Architect's Supplemental Instructions

PROJECT:
Summit Square
Apartments Phase II
 837 NW Donovan Road
 Lee's Summit, MO 64086

ARCHITECT'S SUPPLEMENTAL
INSTRUCTION NO.: 16

At the Owner's request, an addition to serve as the Parcel Storage room was added to Building 1. Additional revisions and clarifications to the scope are summarized per sheet, and reason for the change where applicable:

REVISIONS
● 08.31.2018 - City Comments
● 09.28.2018 - Addendum 2
● 10.30.2018 - Addendum 3
DATE
08/10/2018
JOB NO.
614618
DRAWN BY:
CAD
SHEET NO.
E1.06b

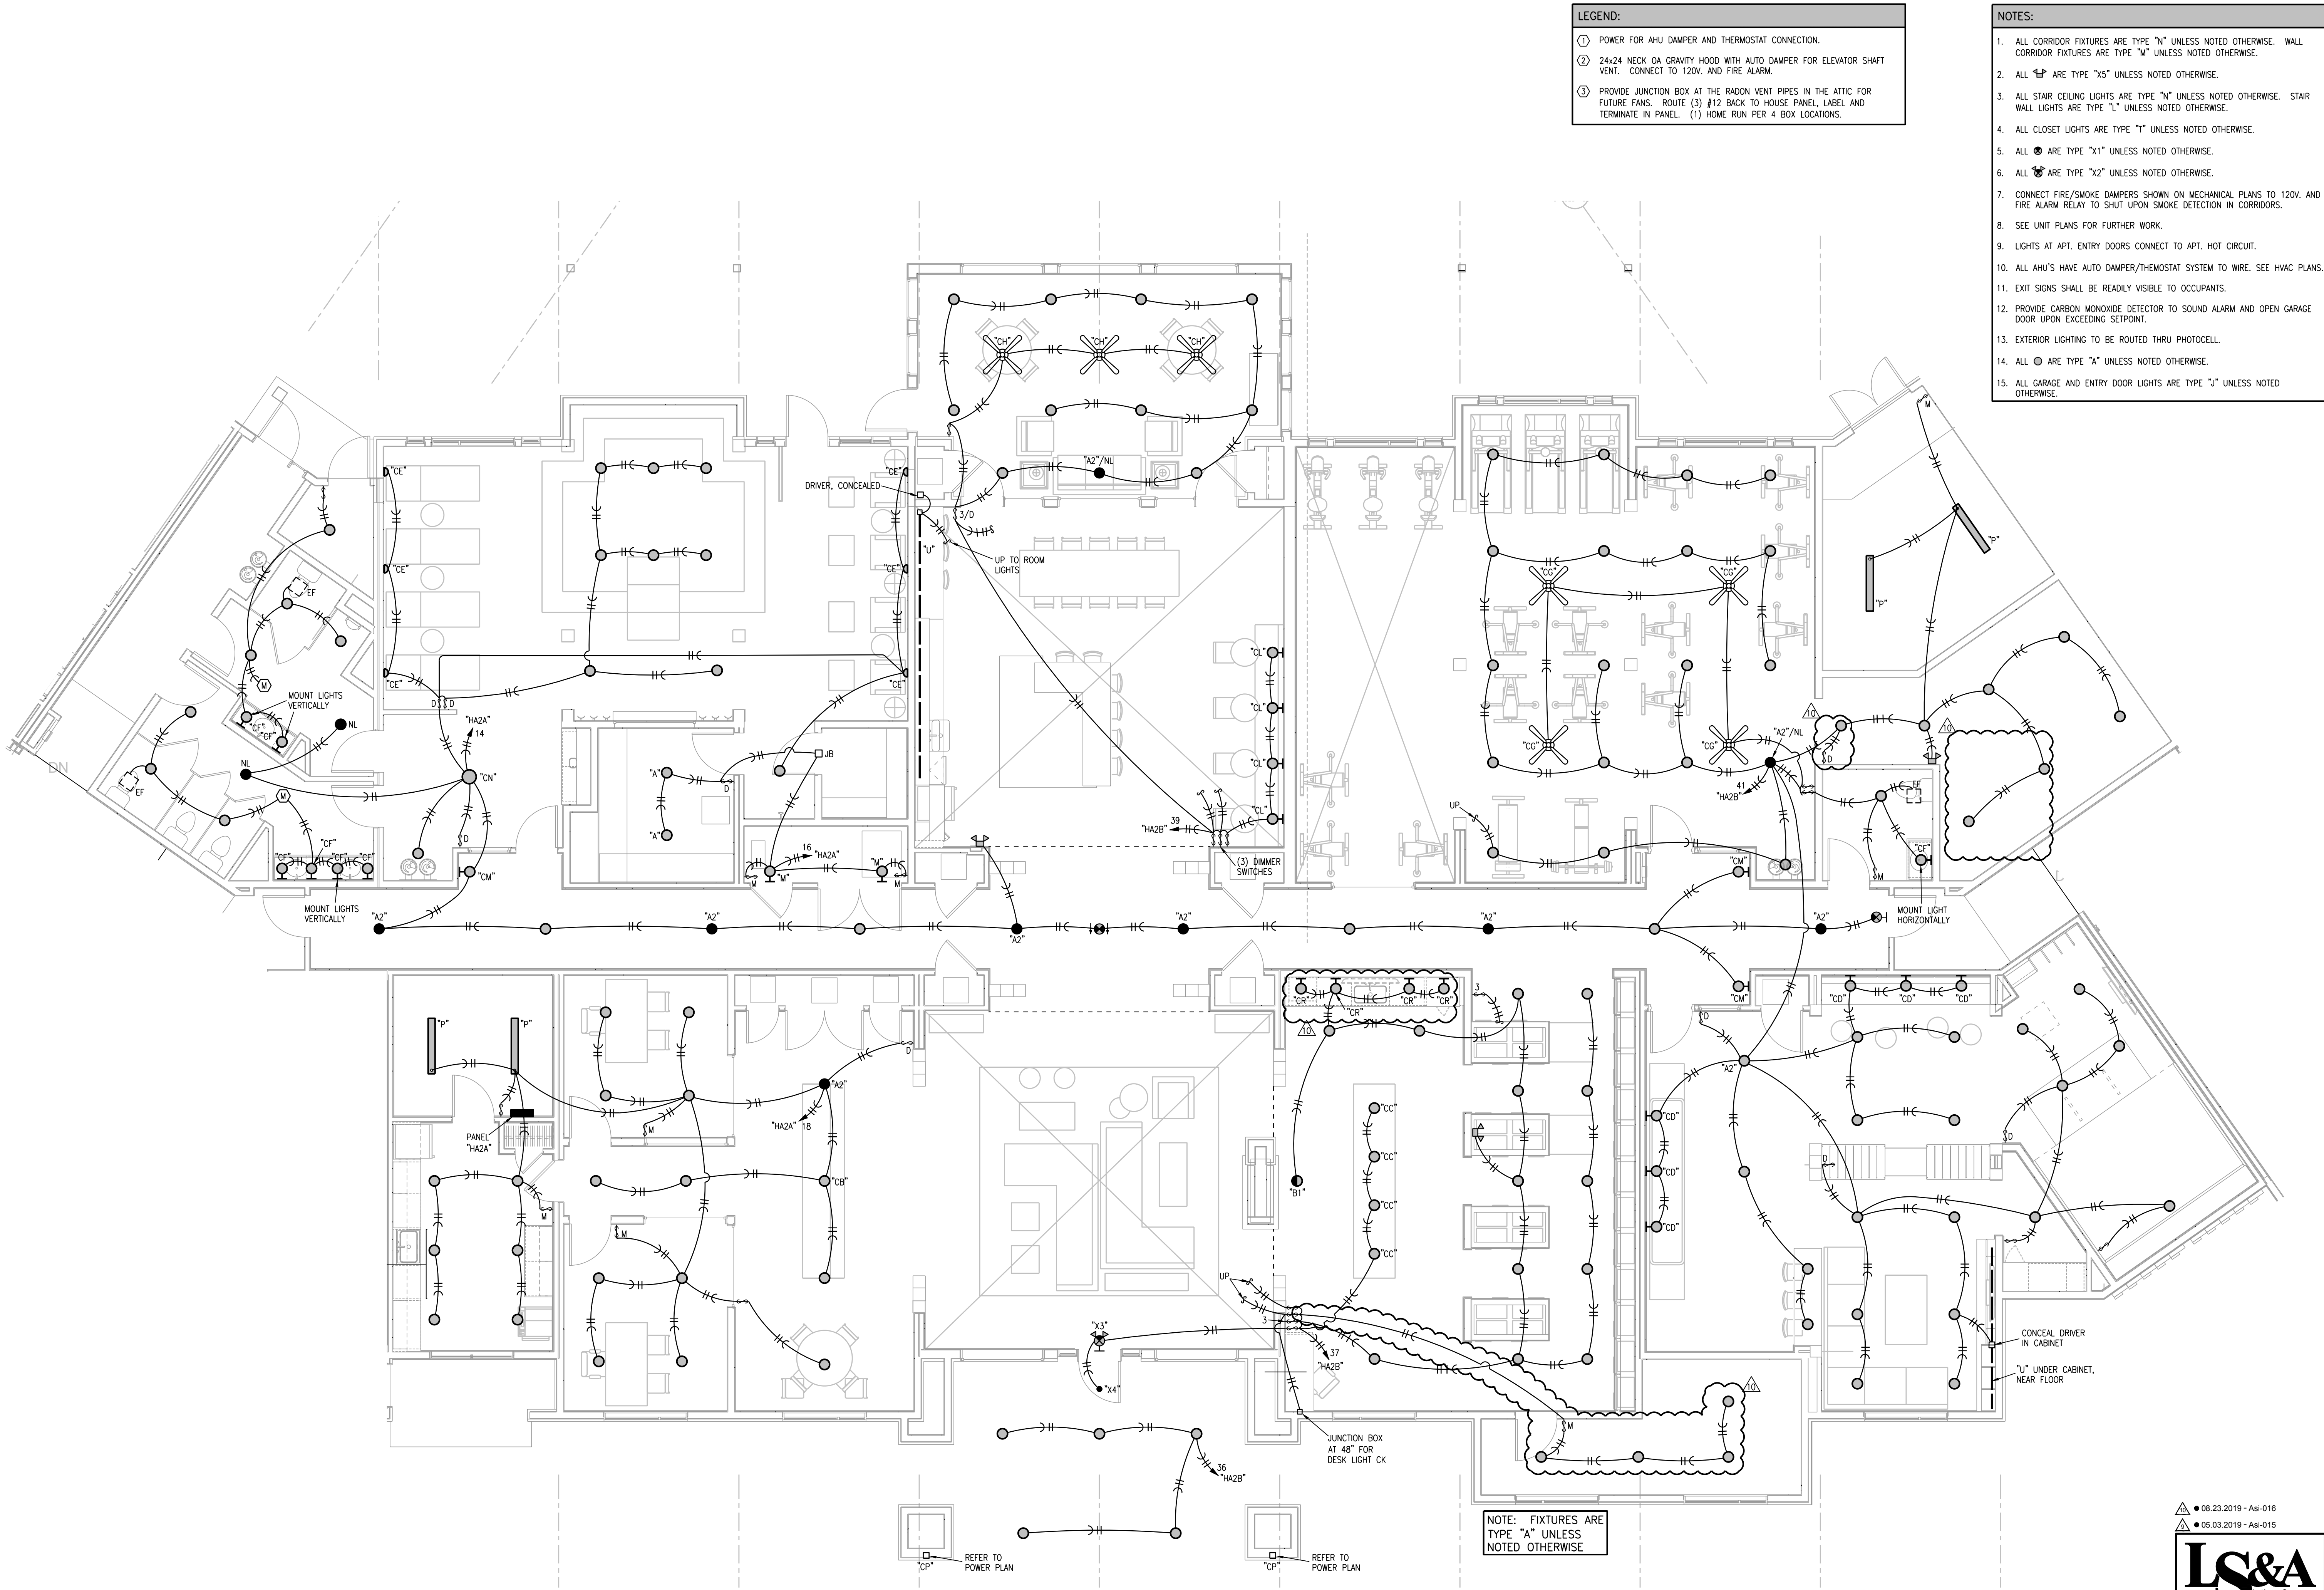
- ME1.02 *Misc. revisions*
- E1.06a *Misc. electrical revisions and additions*
- E1.06b *Misc. electrical revisions and additions*
- E1.07 *Misc. electrical revisions and additions*
- E2.04 *Misc. electrical revisions and additions*
- E2.05 *Misc. electrical revisions and additions*
- E4.05 *Update luminaire schedule per ID selected fixtures*
